ADDENDUM NO. 2

March 1, 2022

**TIMOTHY BALL ELEMENTARY SCHOOL ADDITIONS, RENOVATIONS,
AND RELATED WORK
Crown Point, IN 46307**

This Addendum forms a part of and modifies the Bidding Requirements, Contract Forms, Contract Conditions, the Specifications, and the Drawings dated February 7, 2022 by Gibraltar Design. Acknowledge receipt of the Addendum in the space provided on the Bid Form. Failure to do so may subject the Bidder to disqualification.

PROJECT
**TIMOTHY BALLEES ADDITION
AND
RENOVATIONS**
CROWN POINT COMMUNITY
SCHOOL CORPORATION
CROWN POINT, INDIANA

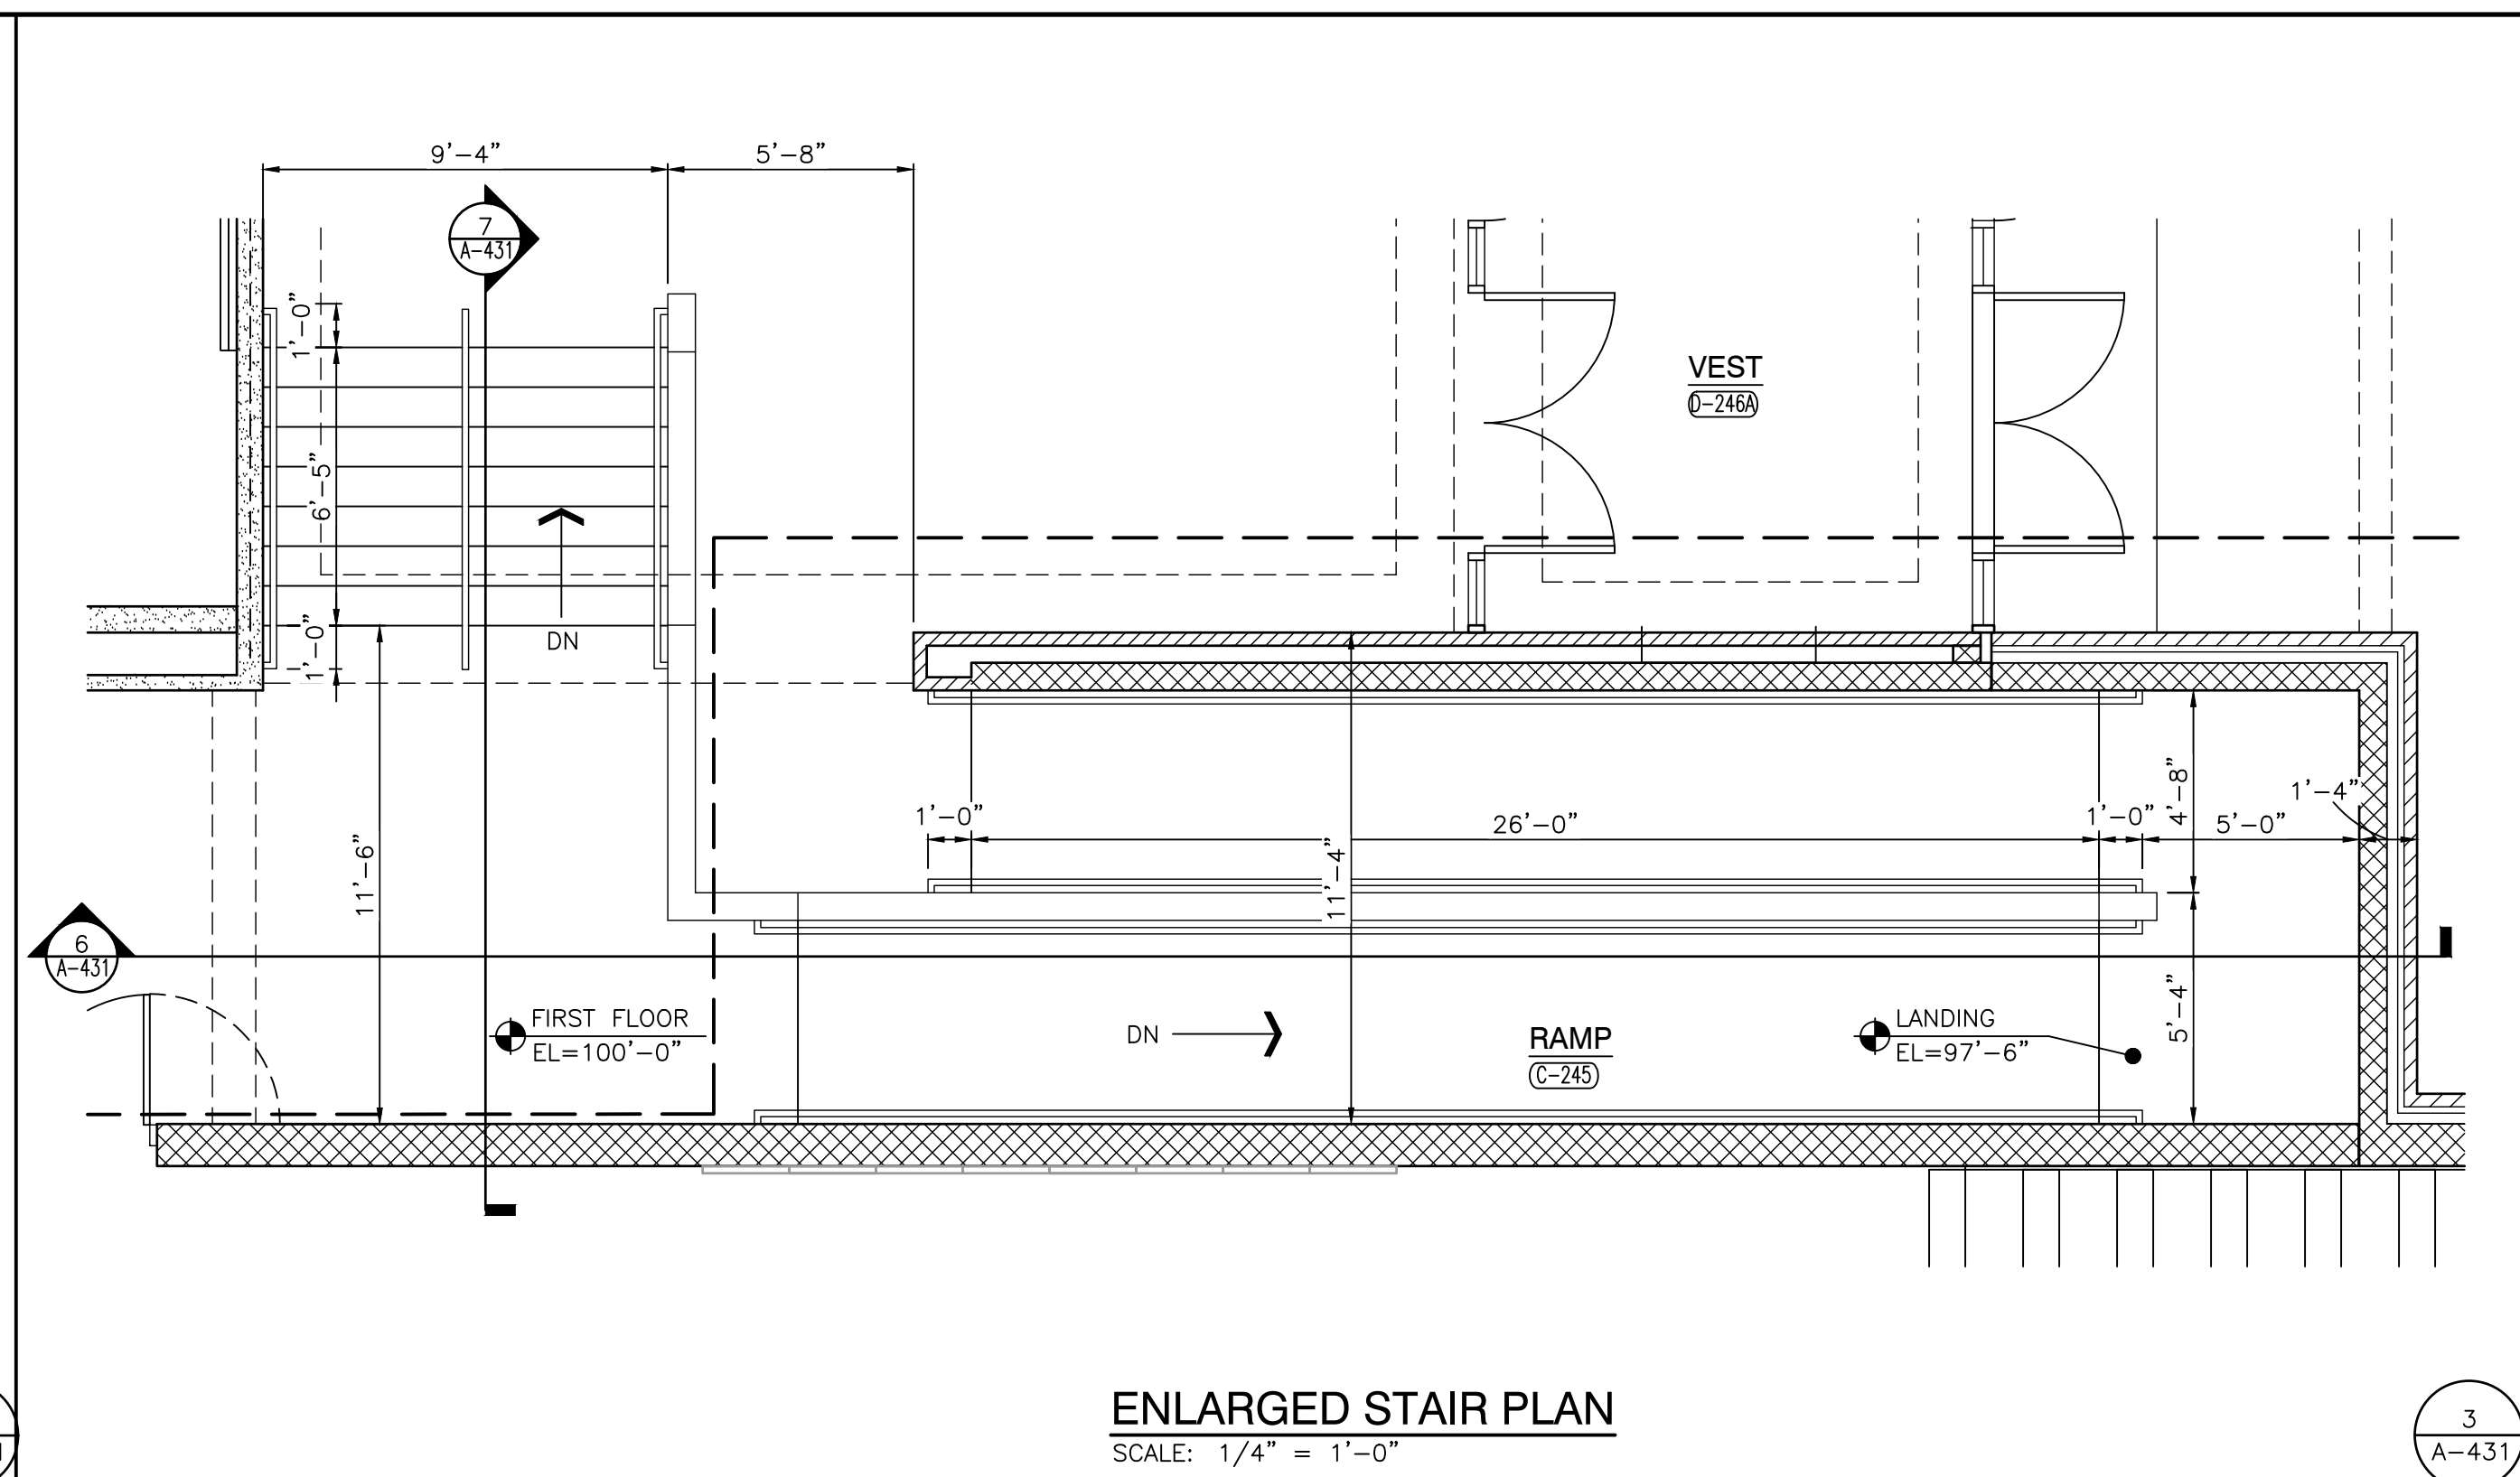
13. Sheet A-416

1. Revise Wall Section 3/A-416.
2. Refer to Section Drawing for clouded dimension revisions in multiple locations.

Friday, 2/25/2022 - 3:38 PM - LAST SAVED BY:MMULLEN
X:\21-112 CROWN POINT CSC - TIMOTHY BALL ES
ADDITION AND RENOVATIONS\21-112 DRAWINGS\05
ARCH\A-502.DWG

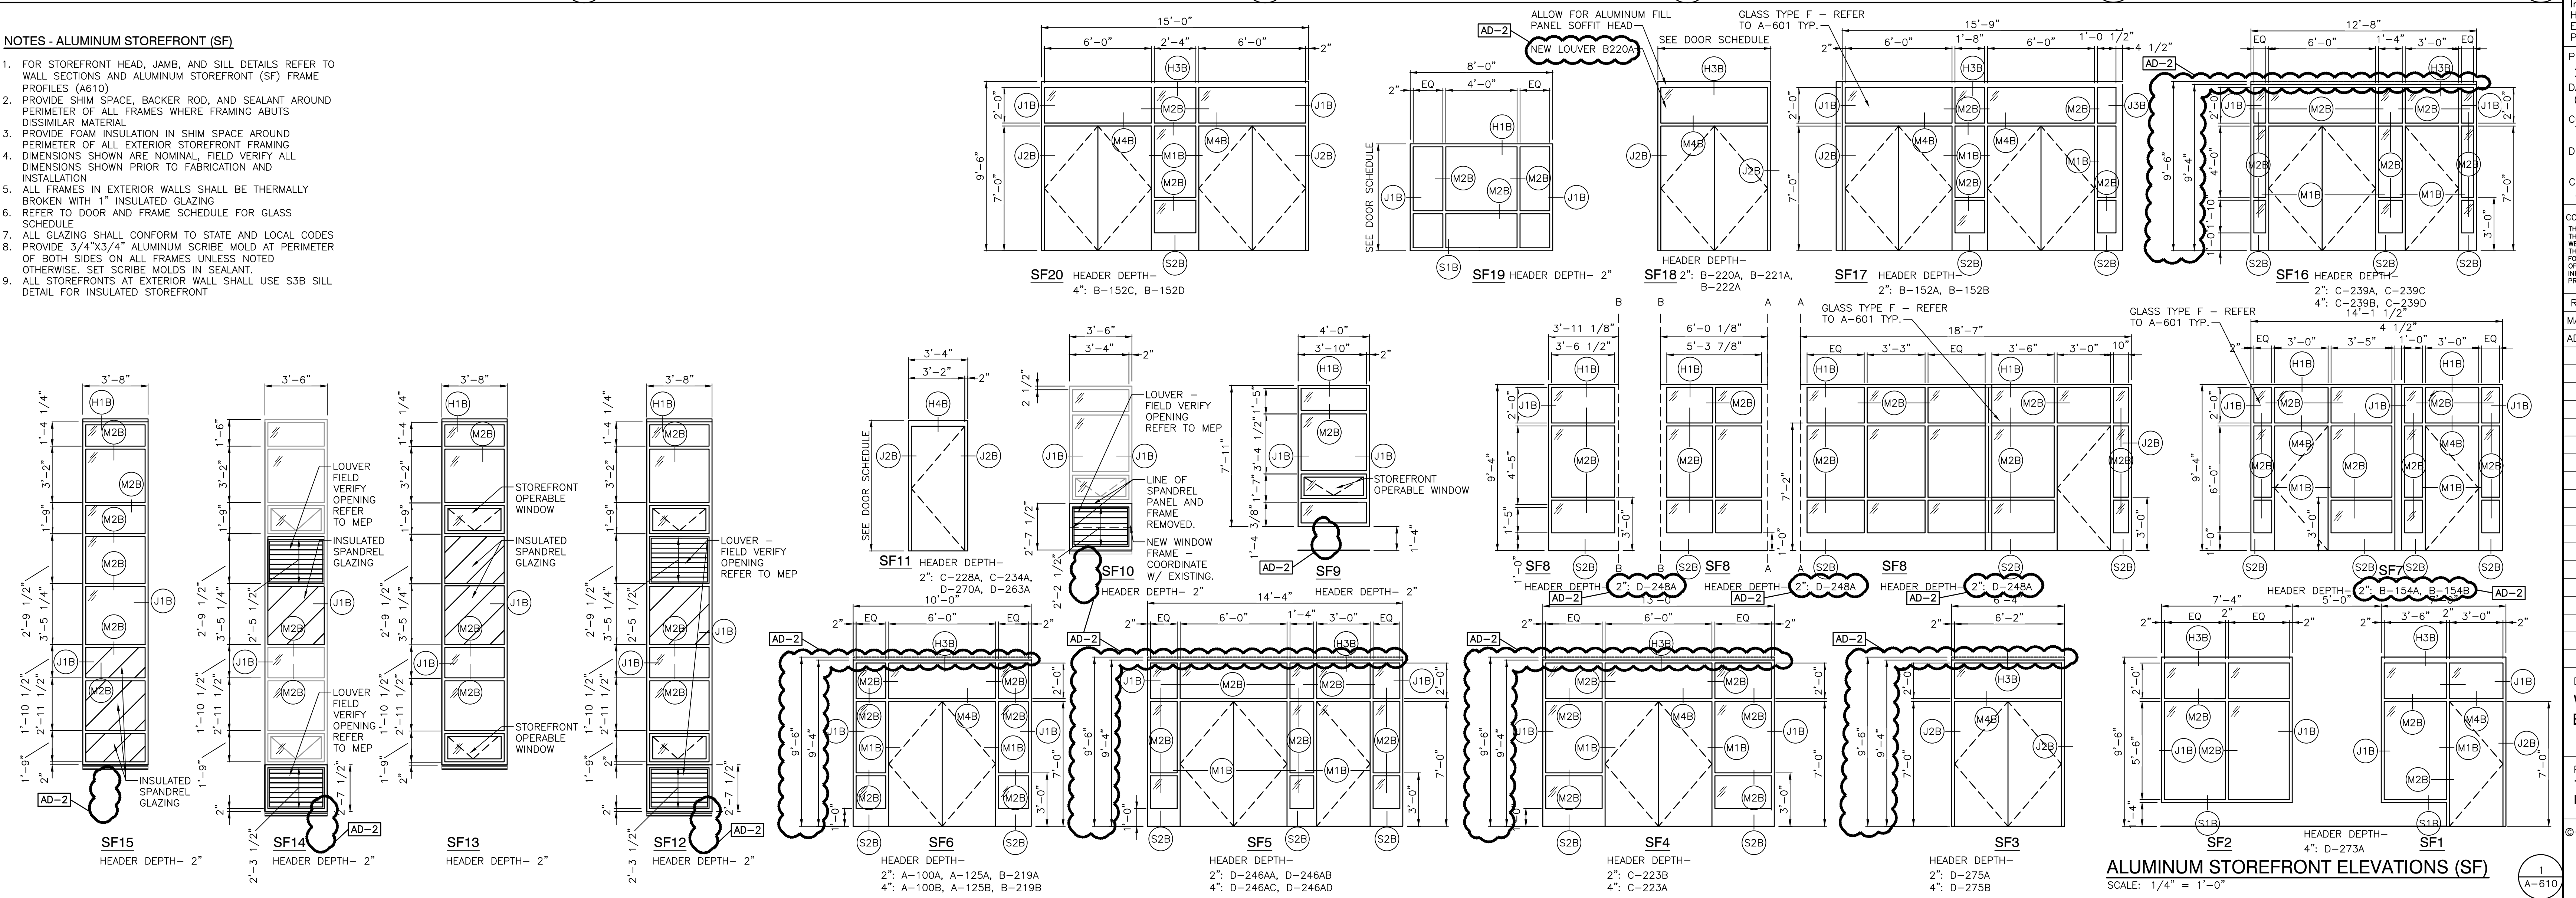
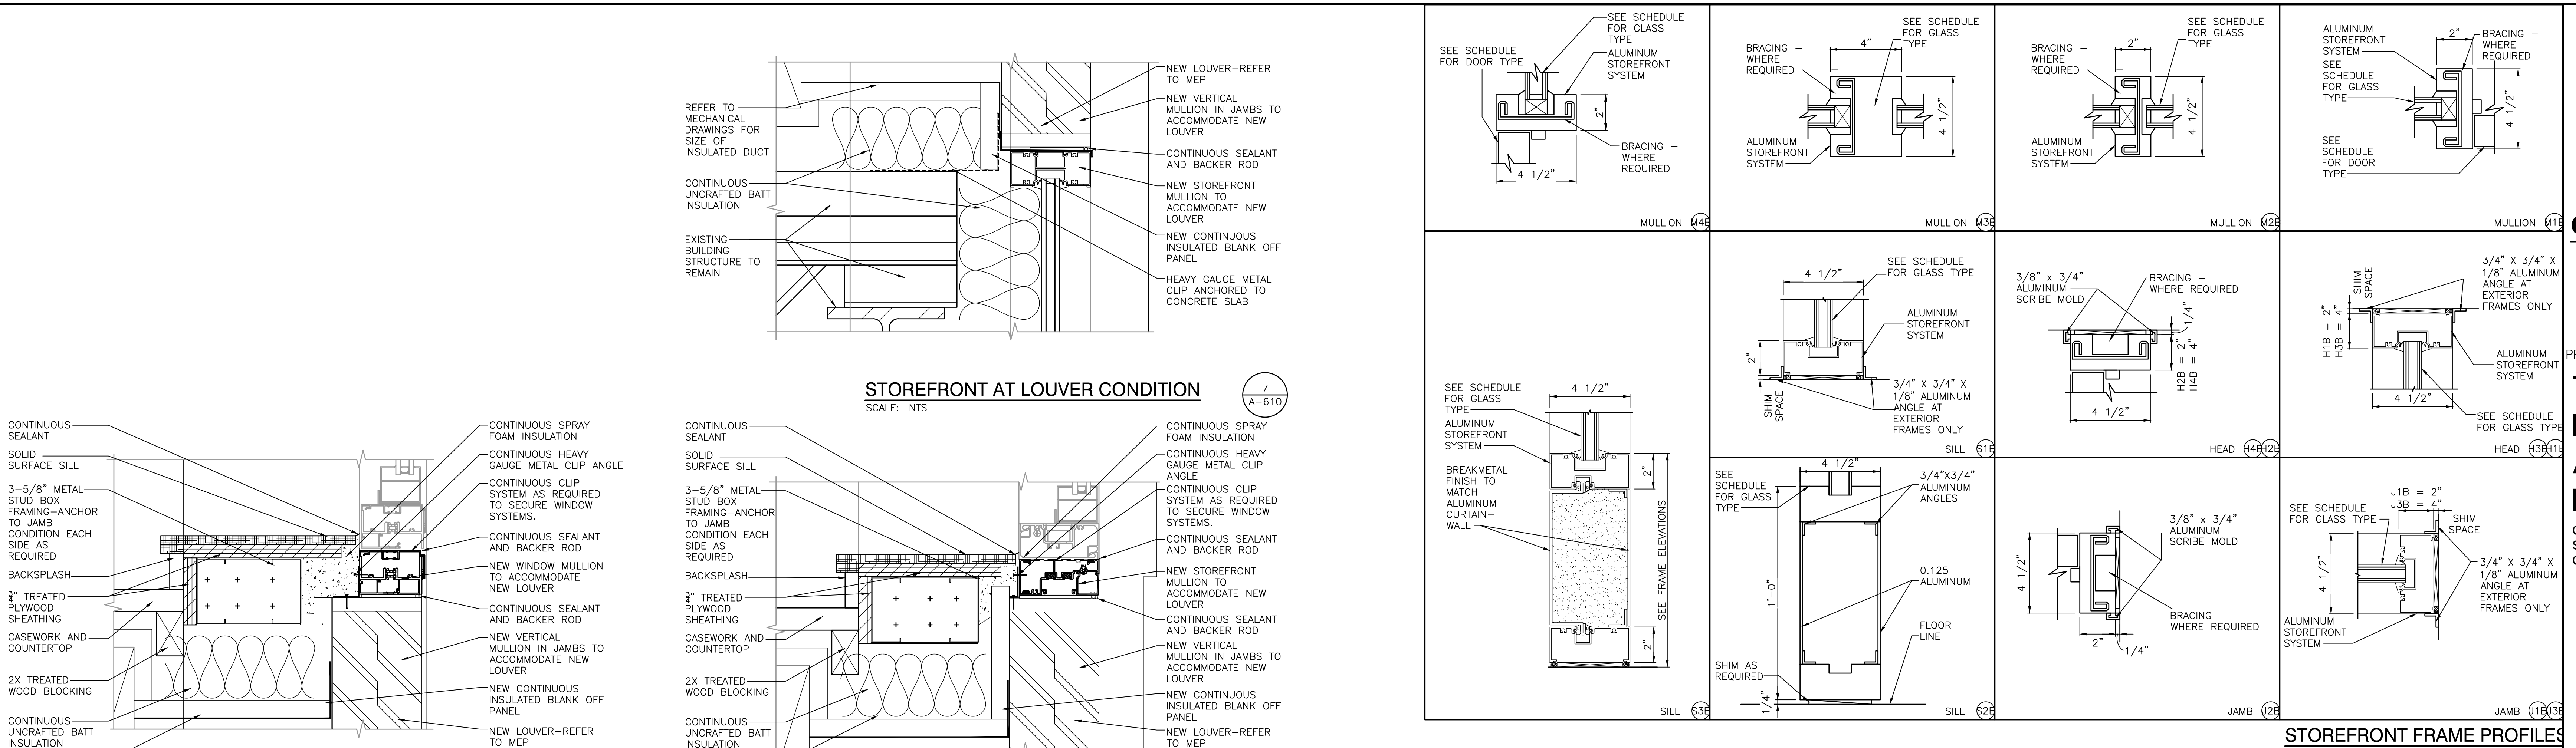
16. Sheet A-502

- A. Refer to revised, full-size drawings, included in this Addendum, for the following revisions:
 - 1. Revise Trash Enclosure in 3/A-502 and 4/A-502.
 - 2. Refer to Drawing for clouded dimension revisions in multiple locations.
